**RESPONSE TO NRC EMAIL DATED AUGUST 18, 2017 –
INFORMATION NEED REQUEST**

**DOMINION NUCLEAR CONNECTICUT, INC
MILLSTONE POWER STATION UNITS 2 AND 3**

NRC August 18, 2017 Email

HAUL PATH FROM BDB STORAGE BUILDING AND STAGING AREAS
FIGURE 1: SHEET 1 OF 2

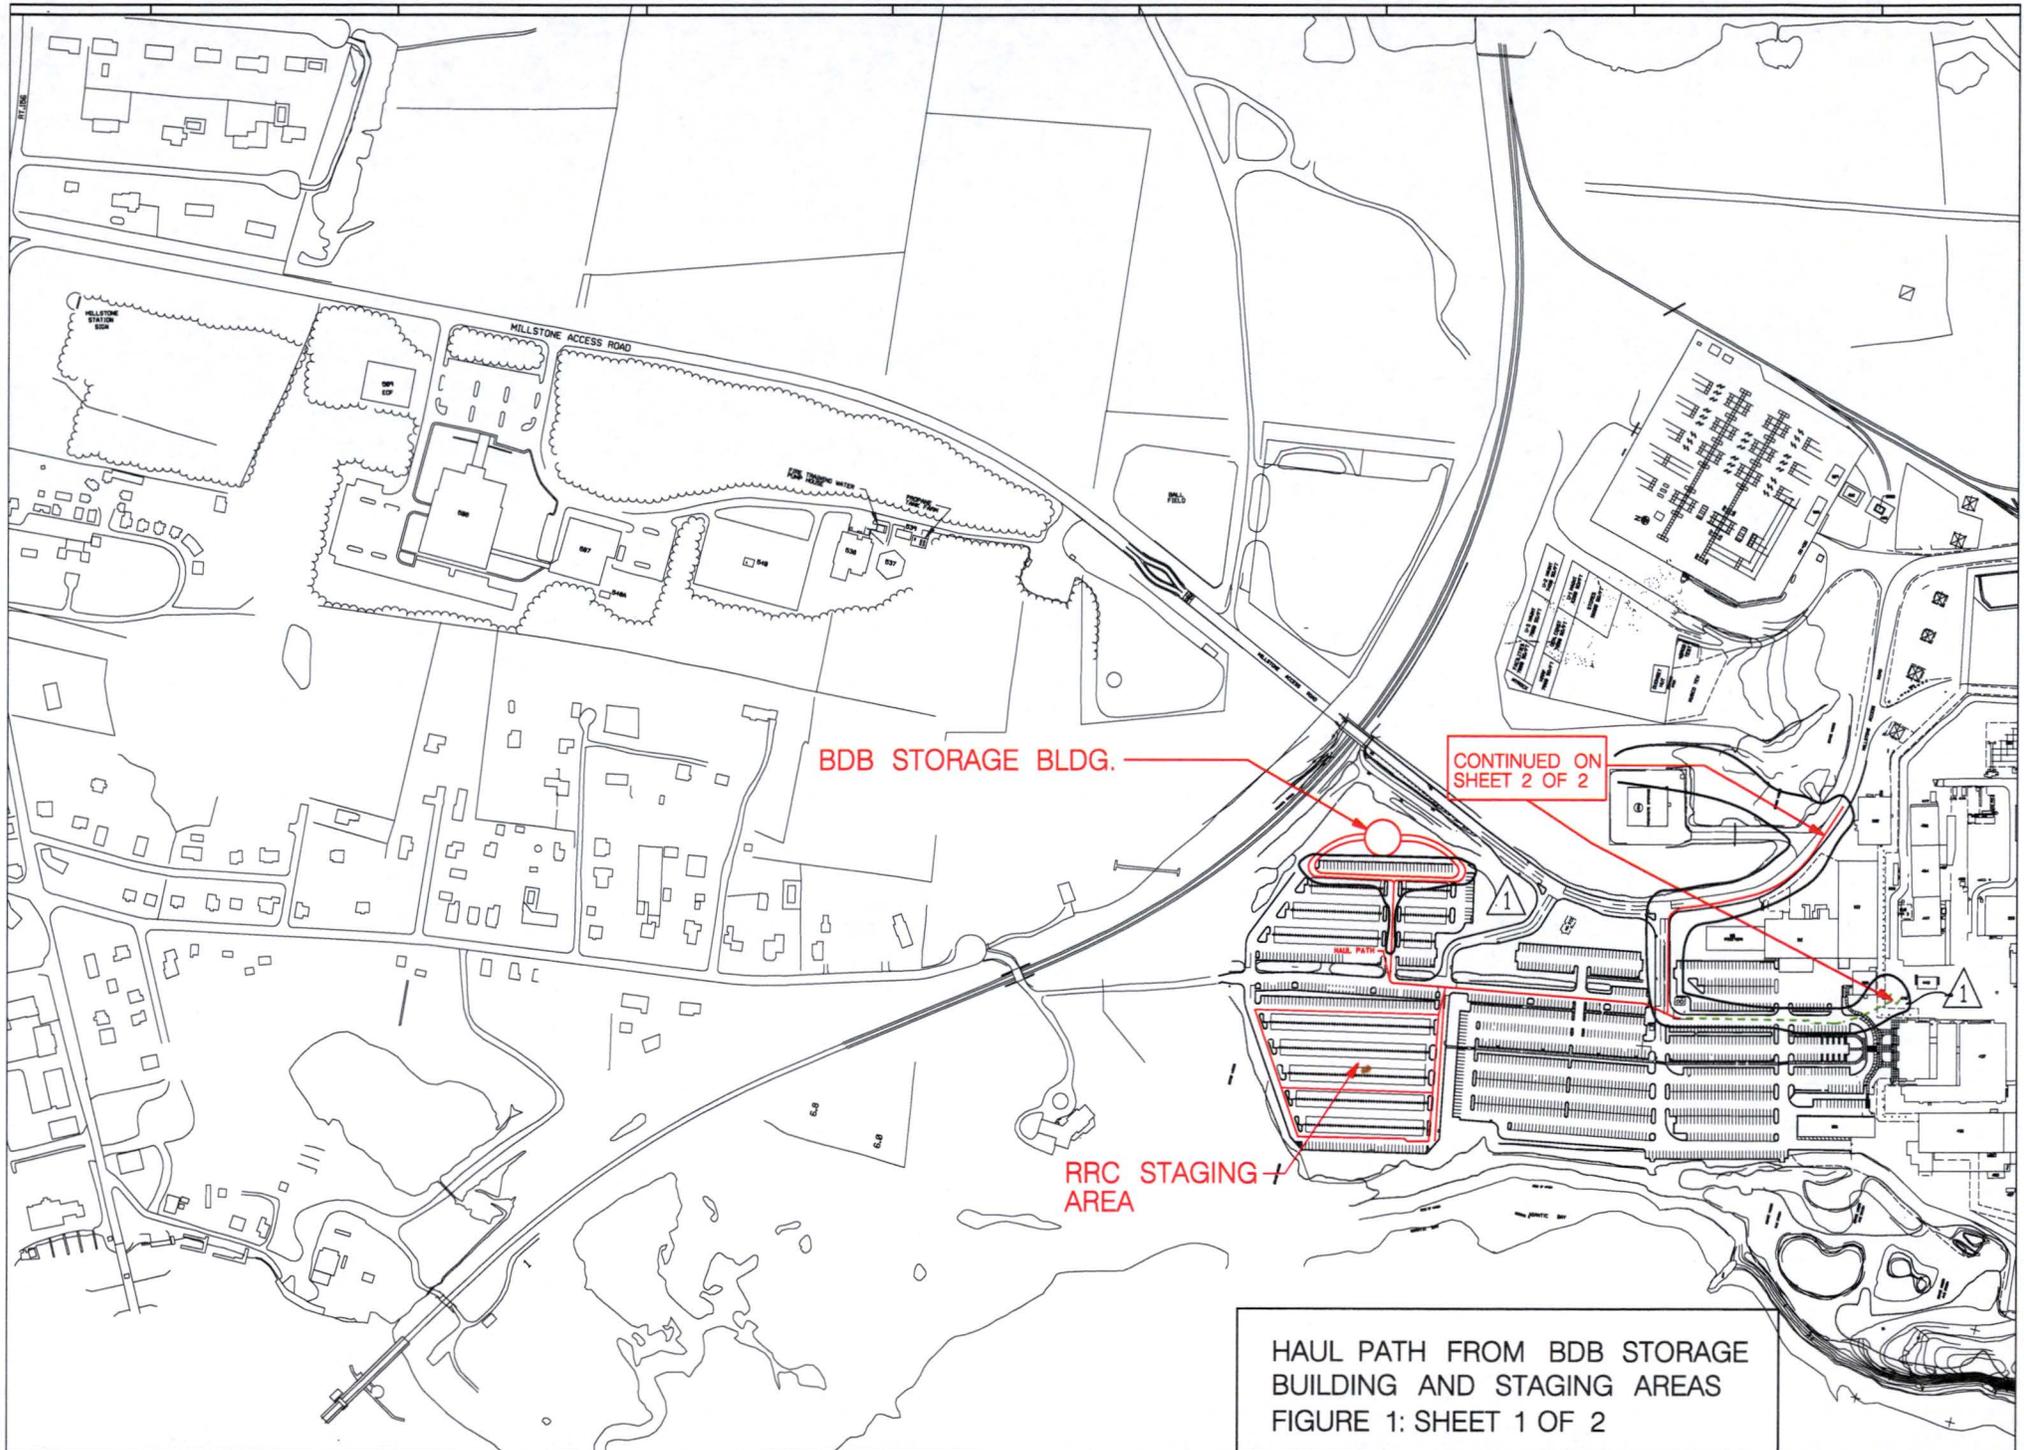
1. Documentation supporting crediting warning time/period for flood protection against the reevaluated LIP flood hazard.
2. Given that the site is expected to be inundated for a period of time following both, the LIP and storm surge floods, please describe any potential impacts to the storage location(s) of FLEX equipment, any staging areas, haul paths, connection points, activities, etc.
3. Location and elevation of buildings housing MPS2 and MPS 3 EDGs and the MPS3 SBO diesel generators.
4. A description of the flood protection features protecting MPS2 and MPS 3 EDGs and the MPS3 SBO diesel generators from the reevaluated unbounded flood hazards.

2. *Potential impacts to the storage location(s) of FLEX equipment, any staging areas, haul paths, connection points, activities, etc. from the:*

An assessment of impact of the reevaluated LIP flood hazard was performed for the FLEX equipment haul paths, FLEX equipment deployment locations, mechanical and electric connection points, and deployment/operations activities. The assessment considered the reevaluated LIP flood hazard flood depths at the time on the FLEX strategy timeline that the associated FLEX strategy actions are required to be executed.

The reevaluated storm surge combined effects flood hazard, with a maximum stillwater elevation of 21 ft, does not inundate the BDB Storage Building located at site grade elevations of approximately 34 – 36 ft, or the Phase 3 FLEX equipment NSRC staging area with grade elevations ranging from approx. 26 – 35 ft . Therefore, the reevaluated storm surge combined effects flood hazard does not impact the BDB Storage Building or the FLEX equipment stored in it, or the NSRC staging area for Phase 3 FLEX equipment.

Assessment of the FLEX equipment haul routes, FLEX equipment deployment locations, and the mechanical or electrical connections concludes that the reevaluated storm surge combined effects flood hazard flood depths inundate the following:
